10/689,710

Office Action Summary

TAGUCHI, HIROYUKI

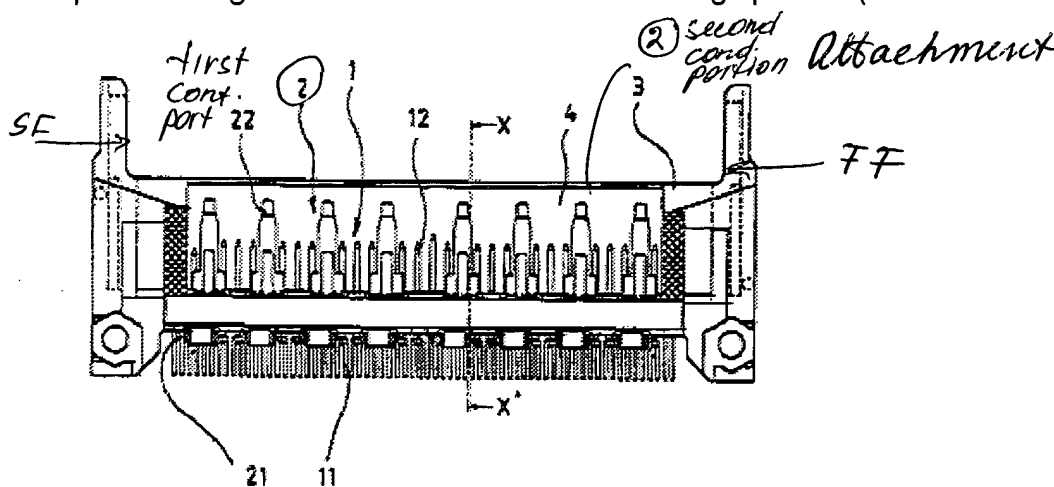
In regard to claim 4, Hirata discloses a second conductor portion 2 disposed along a **second side face SF** of the housing space 4; wherein the first conductor portion 2 is disposed along a first side face FF of the housing space 4 (see Attachment).
